3/4.3 INSTRUMENTATION

3/4.3.1 REACTOR PROTECTION SYSTEM INSTRUMENTATION

PY-CEI/NRR-1694
Attachment 2
Page 10 of 54

TABLE 3.3.3-1

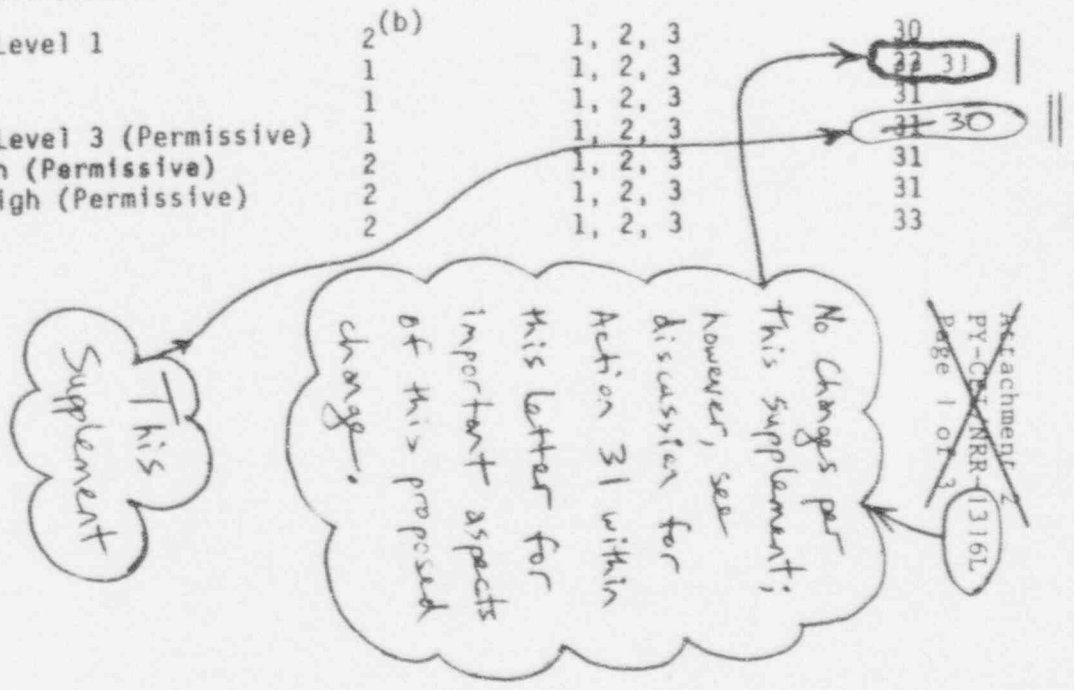
REPLACE WITH INSERT

- (a) When a channel is placed in an inoperable status solely for performance of required Surveillances, entry into associated ACTIONS may be delayed as follows: (a) for up to 6 hours for Trip Functions C.1.f, C.1.g, and C.1.h; and (b) for up to 6 hours for Trip Functions other than C.1.f, C.1.g, and C.1.h provided the associated Trip Function maintains ECCS initiation capability.

TABLE 3.3.4.1-1

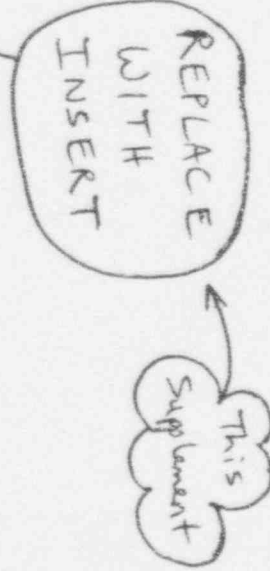
(a) One channel may be placed in an inoperable status for up to 2 hours for required surveillance provided the other channel is OPERABLE.

- (a) When a channel is placed in an inoperable status solely for performance of required Surveillances, entry into associated ACTIONS may be delayed for up to 6 hours provided the associated Trip Function maintains ATWS-RPT trip capability.

TABLE 3.3.5-1

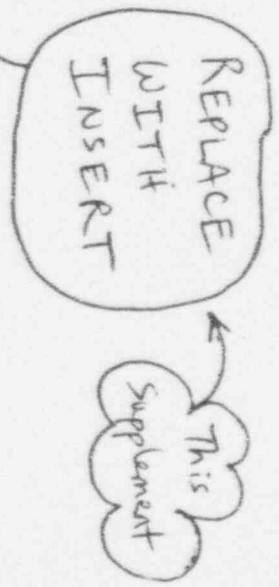
(a) A channel may be placed in an inoperable status for up to 2 hours for required surveillance without placing the trip system in the tripped condition provided at least one other OPERABLE channel in the same trip system is monitoring that parameter.

INSERT 5:

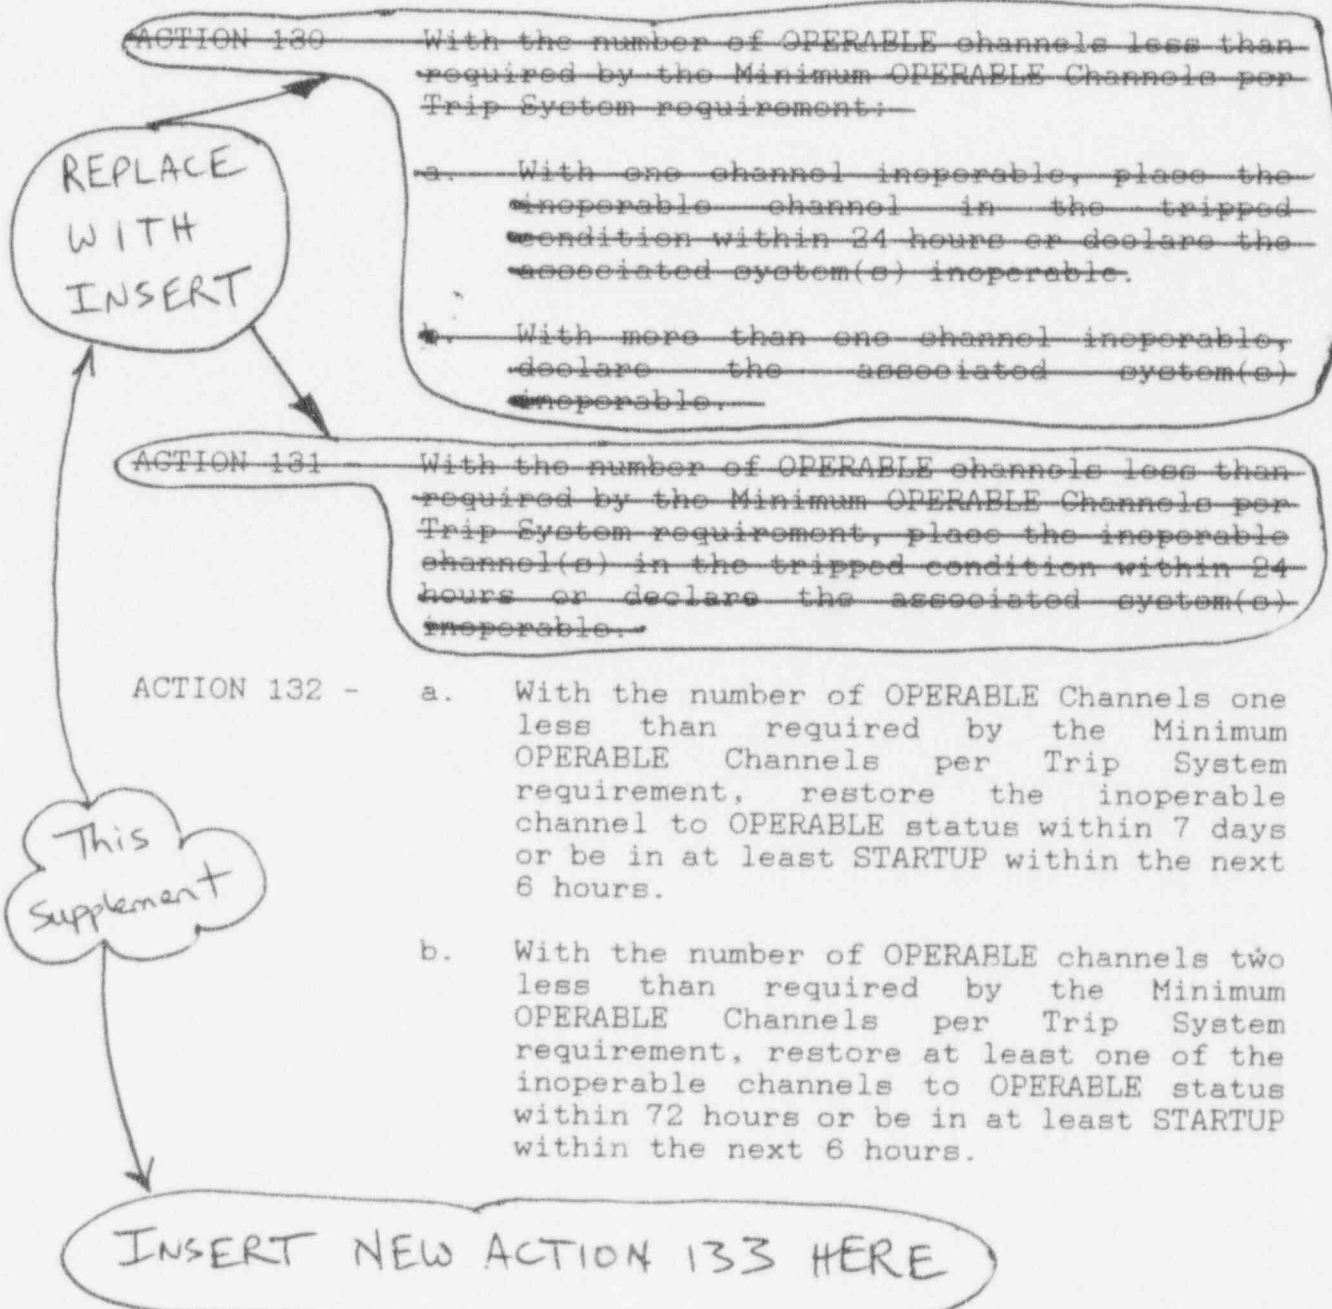
TABLE 3.3.9-1 (Continued)
PLANT SYSTEMS ACTUATION INSTRUMENTATION
ACTIONS

ACTION 130 - With the number of OPERABLE channels less than required by the Minimum OPERABLE Channels Per Trip System requirement, verify within one hour that a sufficient number of channels remain OPERABLE or are in the tripped condition to maintain automatic actuation capability of either subsystem A or subsystem B, and place the inoperable channel(s) in the tripped condition within 24 hours. Otherwise, declare the associated subsystem(s) inoperable.

ACTION 131 - With the number of OPERABLE channels less than required by the Minimum OPERABLE Channels Per Trip System requirement, verify within one hour that a sufficient number of channels remain OPERABLE to maintain automatic actuation capability of either subsystem A or subsystem B, and restore the inoperable channel(s) to OPERABLE status within 24 hours. Otherwise, declare the associated subsystem(s) inoperable.
